TO: Mercedes-Benz Dealer Principals, General Managers, Sales Managers, Service Managers, Parts Managers	FROM: Gregory Gunther, Senior Manager, Vehicle Compliance and Analysis, Engineering Services
RE: Service Campaign Launch Notification Wax Inside of Integral Carrier MY23-24 EQE Sedan (295 platform)	DATE: March 15, 2024

Campaign No. 2024020011, March 2024

SUBJECT: **Model EQE (295 platform)**
Model Year 2023 – 2024

Wax Inside of Integral Carrier

Figure 1 Vehicle underside in direction of travel (arrow A)

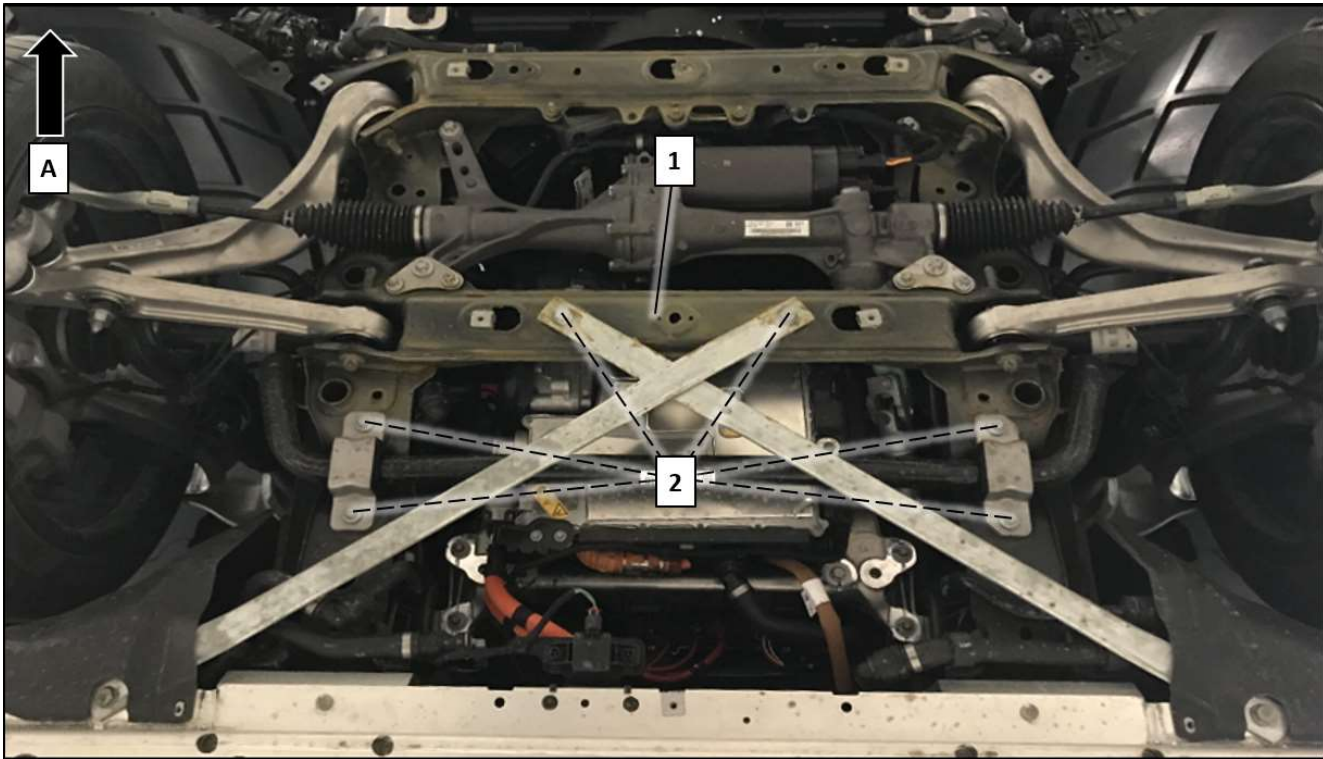
2. Wax the inside of the integral carrier (Figures 1 and 2, 1) in the area of the rivet nuts (Figures 1 and 2, 2) with cavity preservation wax.

Figure 2 Underside of integral carrier (1) in direction of travel (arrow A)

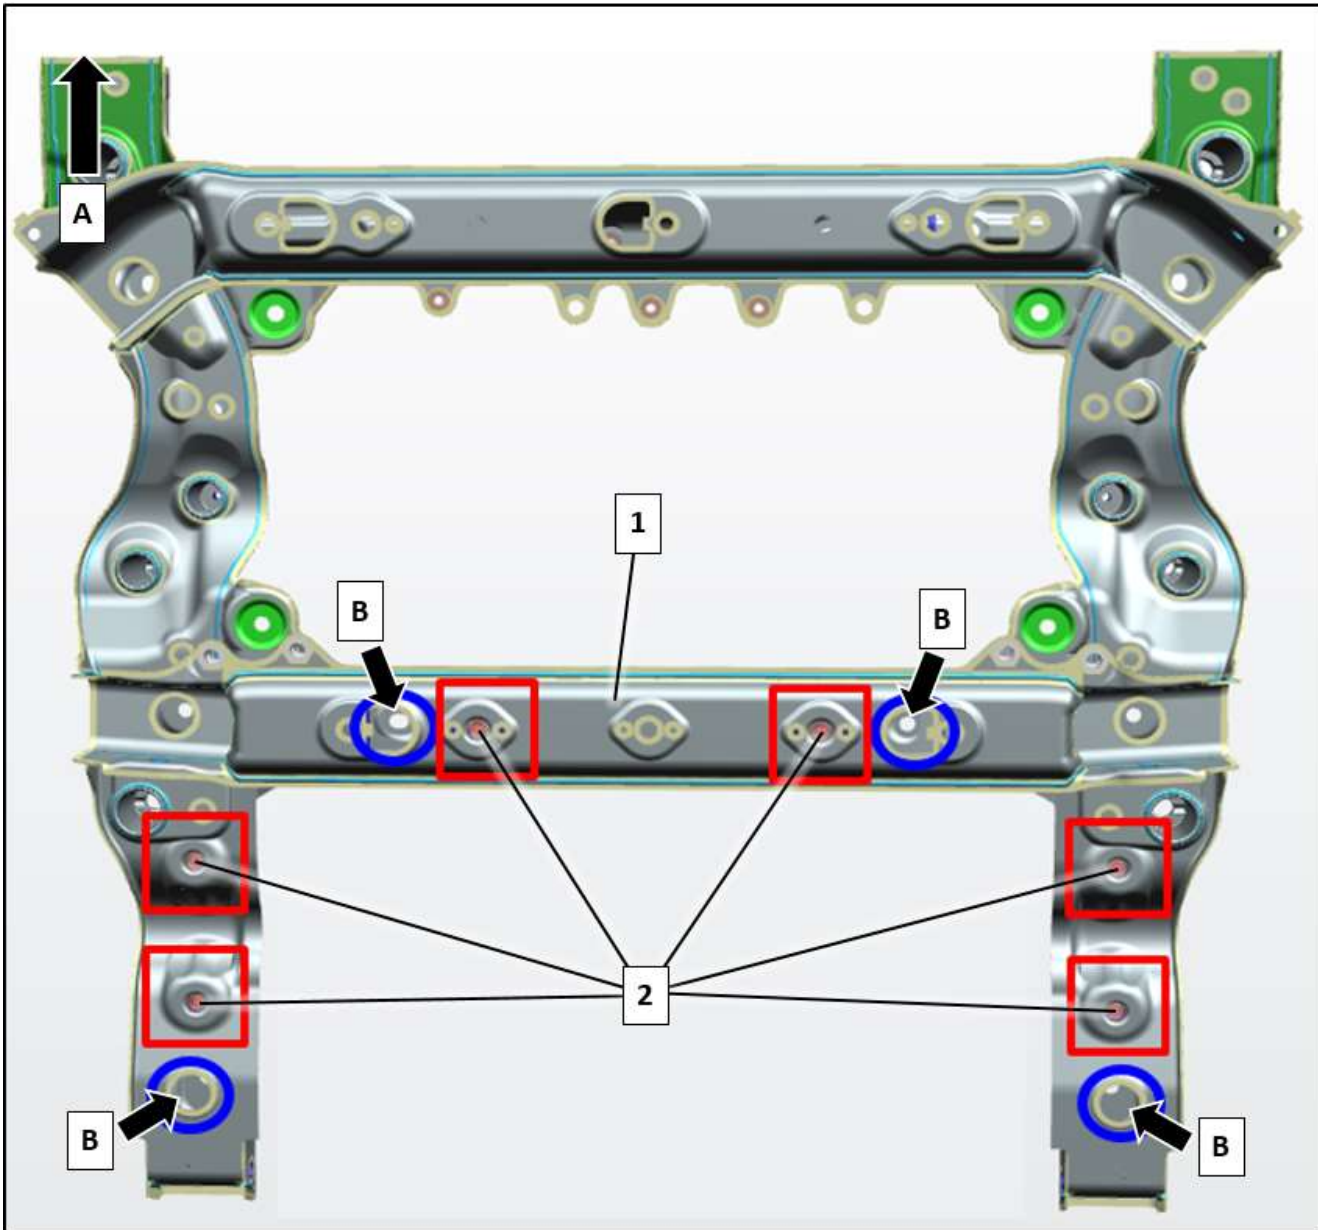
Insert the wax nozzle into the appropriate opening (Figure 2, → B) of the integral carrier (Figure 2, 1). From these openings, the cavity preservation wax converges at the lowest point for each of the 6 rivet nuts (Figure 2, 2). Therefore, it is not necessary to hit the rivet nut points exactly; it is sufficient to create a local excess of cavity preservation wax.

Ensure a sufficient amount of wax is applied.
